Proposed Solar Power Station, Kells: LA03/2015/0234/F

HAVING REVIEWED THE ENVIRONMENTAL STATEMENT (ES) SUBMITTED BY RPS ON BEHALF OF THE APPLICANT KellsVOCAL HEREBY SUBMIT OUR DETAILED OBJECTION TO THIS PLANNING APPLICATION.

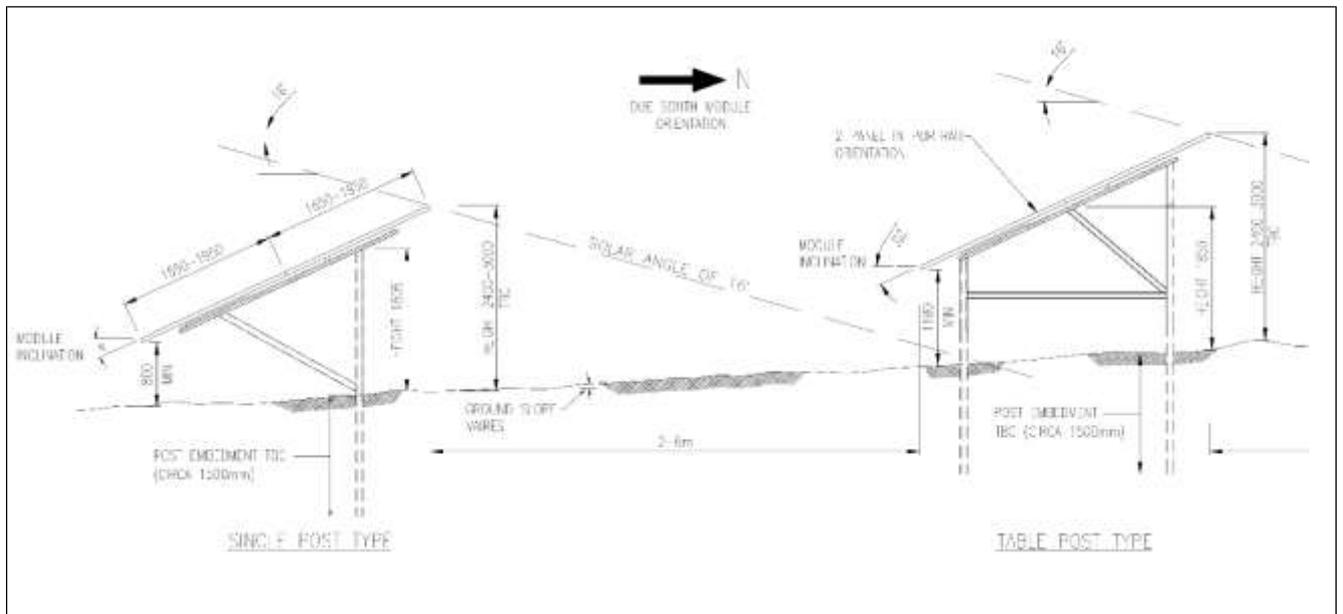
A block layout plan is required in order that various impact assessments can be carried out

Without a fully annotated block plan the “worst case scenario” cannot be assessed

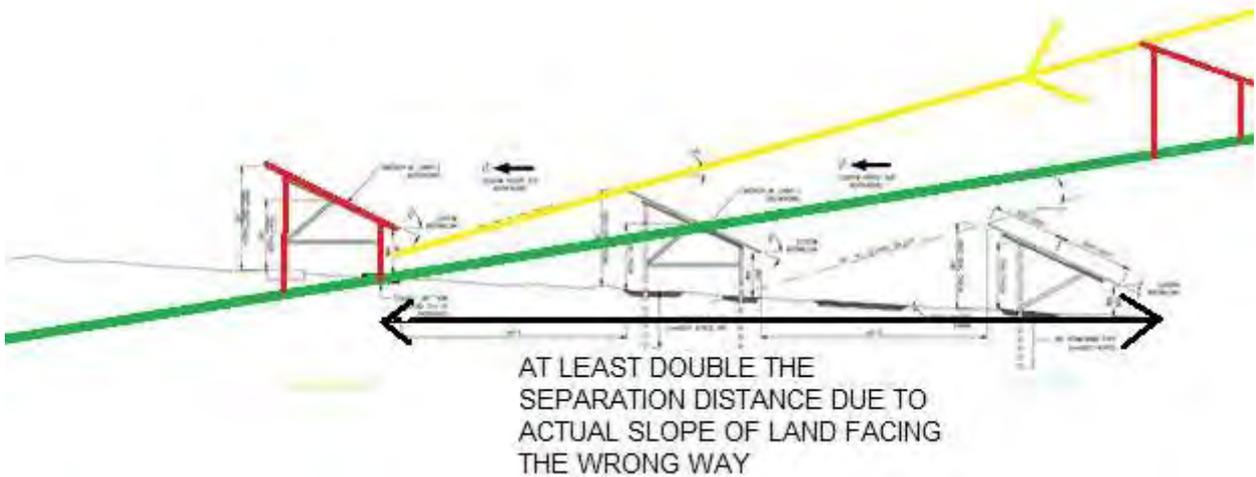
PLEASE NOTE THE ABOVE MAP WAS NOT SUBMITTED WITH THE PLANNING APPLICATION

The contour map submitted with the application had the contours hidden beneath the schematic array layout.

Figure 8.1 Watercourses through the site
 THE SEVERAL LAKES AND THEIR INLETS & OUTLETS ARE NOT IDENTIFIED

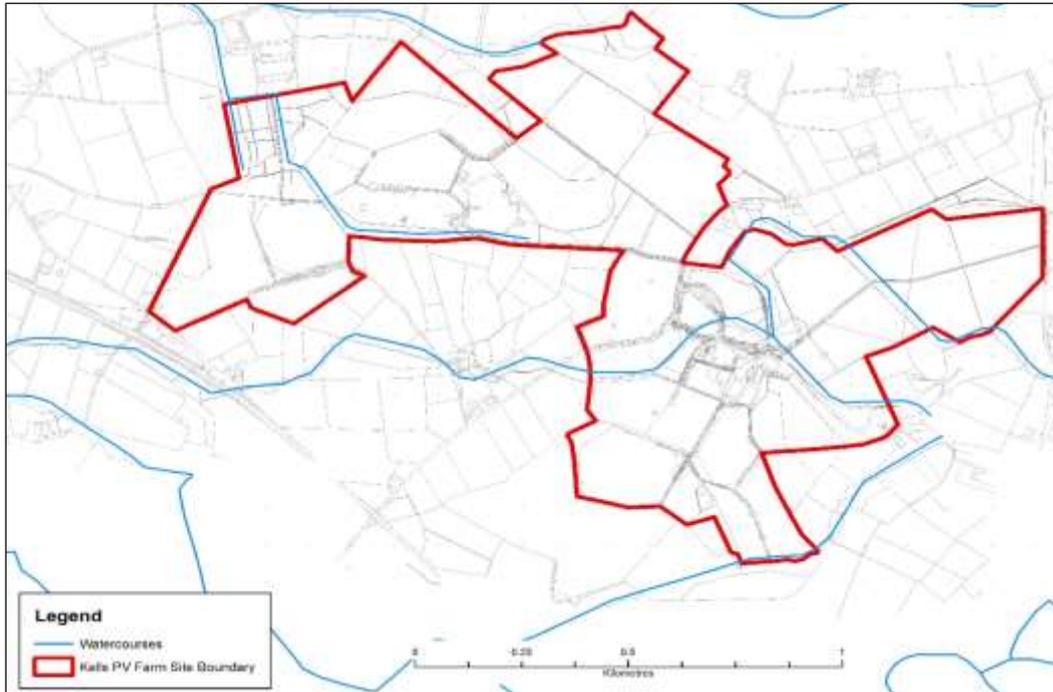
THE AGENT DOES NOT TAKE ACCOUNT OF THE LAKE SET INTO A LOW LYING AREA OF THE SITE. THE RUN OFF FROM 39 HECTARES OF GLASS PANELS FLOWING INTO THIS LOW LYING AREA COULD RESULT IN THE PANELS AND INVERTERS BEING SUBMERGED CAUSING THE WHOLE SITE TO SHORT AND CAUSE ELECTROCUTION AND POSSIBLE EXPLOSIONS.

NO ASSESSMENT HAS BEEN MADE OF THE HAZARDS ASSOCIATED WITH THE SUBMERGING OF EXTENSIVE AREAS OF LIVE SOLAR PANELS

Figure 8.2 Extract from Rivers Agency Indicative Flood Map- River Flooding

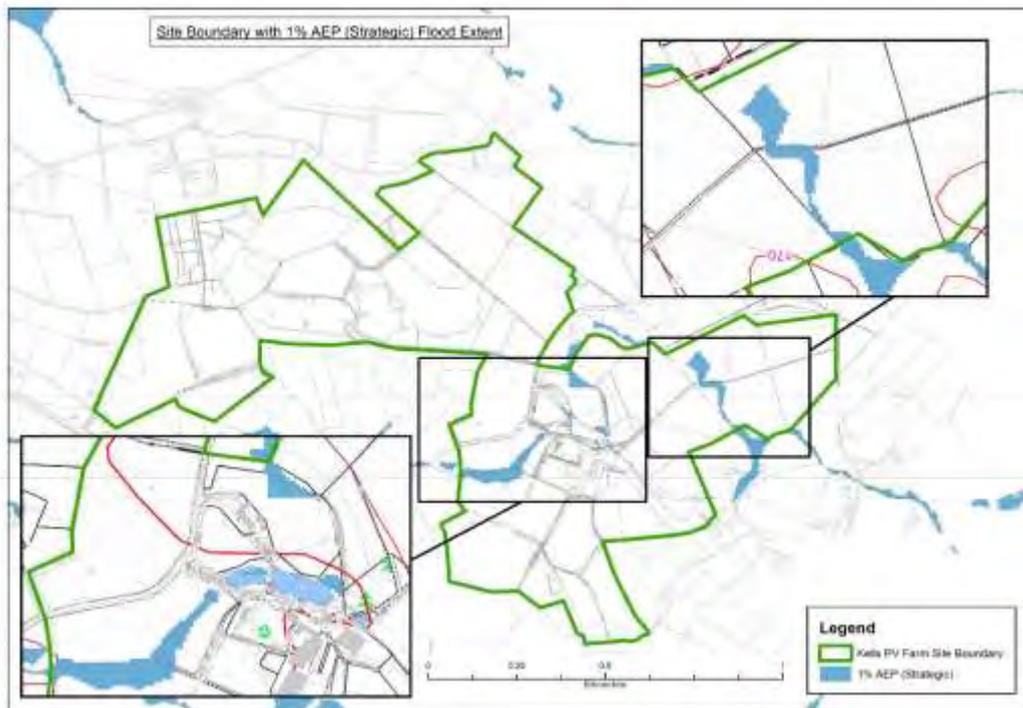
THE USE OF INDICATIVE INFORMATION IS NOT ACCEPTABLE. SUCH A MASSIVE PROPOSAL WHERE THE SCALE OF FLOODING IS IDENTIFIED IN THE MAP BELOW REQUIRES A FULLY DETAILED ASSESSMENT.

IN THE ABSENCE OF A FULLY DETAILED SITE SURVEY THE DEPARTMENT MUST USE THE PRECAUTIONARY PRINCIPLE AND REFUSE THIS APPLICATION ON THE GROUNDS THAT THE RUN-OFF FROM 39 HECTARES OF GLASS PANELS DISCHARGING INTO MINOR WATERCOURSES HAS THE POTENTIAL TO CAUSE MAJOR FLOODING.

Fig. 8.3 Extract from Rivers Agency Indicative Flood Map- Surface Water Flooding

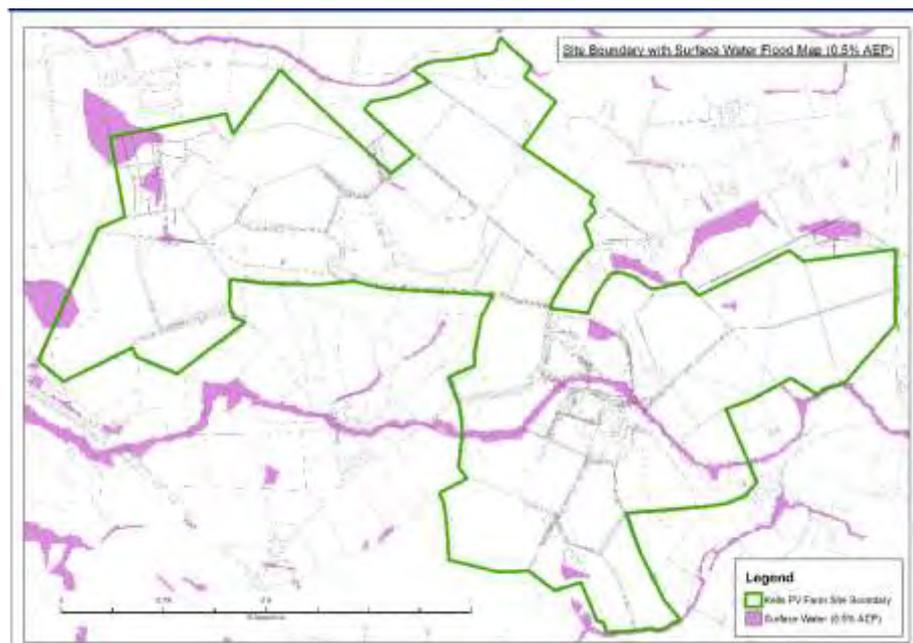
FIGURE 8.3 IS NOT APPROPRIATE AS IT RELATED TO LAND IN ITS CURRENT USE AND NOT AN ASSESSMENT OF THE IMPACT AFTER 250 ACRES OF LAND HAS BEEN COVERED IN SOLAR PANELS. THE DEPARTMENT MUST UNDERTAKE AN INDEPENDENT REVIEW TO ENSURE THAT INFORMATION SUPPLIED IS UNBIASED AND ROBUST ENOUGH TO BASE DECISION UPON.

Figure 16.3 Mean monthly sunshine (1981 - 2010) and extremes (1929 - 2002) at Aldergrove (Source: Met office)

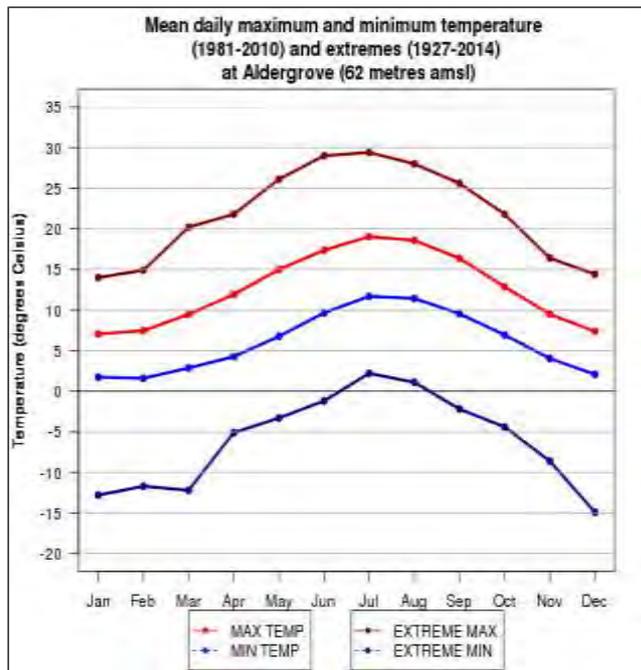
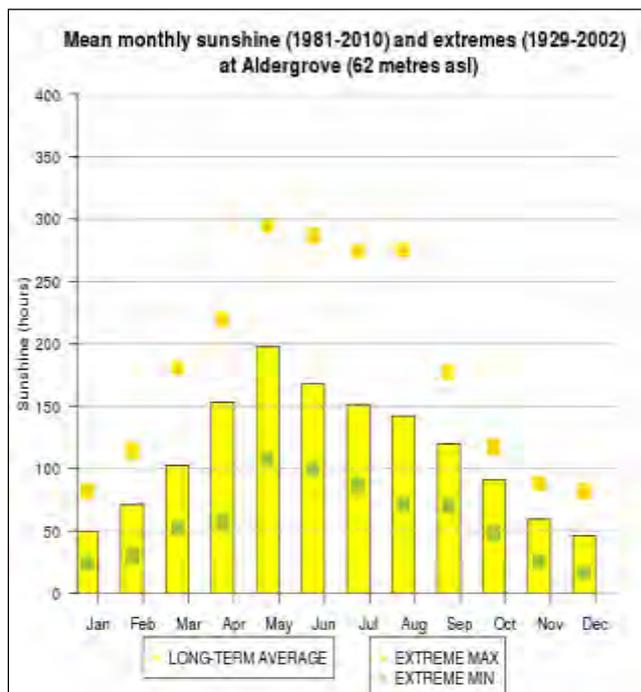
Aldergrove is some distance from the proposed site and also at different altitudes, this renders the enclosed information irrelevant to the proposed development. Given the size and nature of the proposed development a site specific evaluation would have been expected or as a minimum a comparison of the data from surrounding meteorological stations.
